## Certificate of Appropriateness

1217 E. BRADY ST. **Property**

**Brady Street HD**

**Date issued** 7/11/18 PTS ID 114574 COA: replace projecting sign

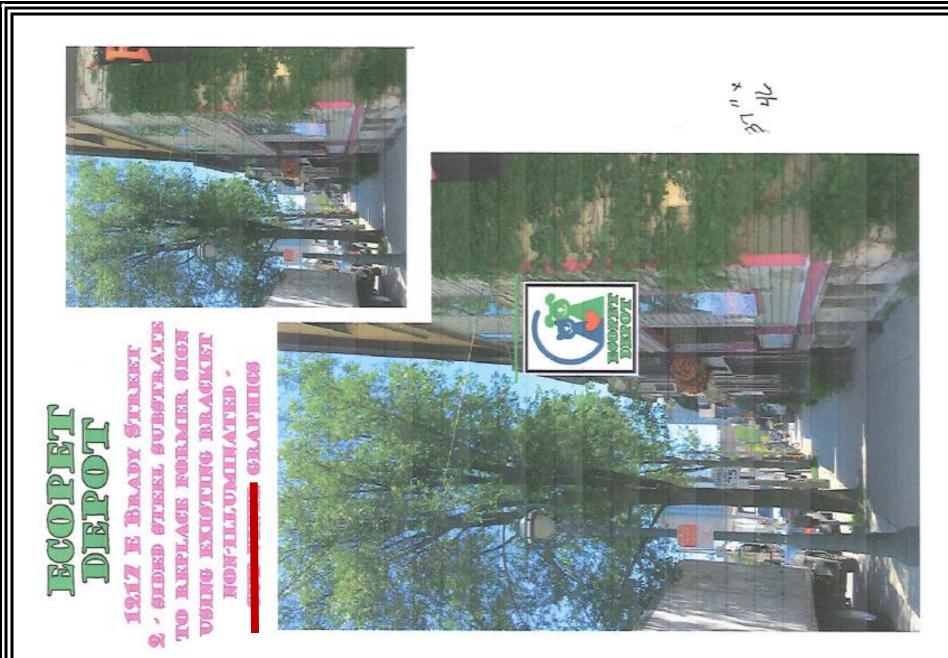
Sign must be painted or all text and graphics must be raised from the surface at least 1/8". Vinyl applique is not permitted

Construct of solid material, plywood edges may not be exposed and corrugated plastic is not acceptable. . Sign thickness shall be no greater than 1". Sign may be reduced in size to meet permitting requirement. This Certificate of Appropriateness is not intended to permit sizes larger than those allowed by zoning.

All graphics and lettering shall be painted or be a raised surface. Cut vinyl is not allowed.
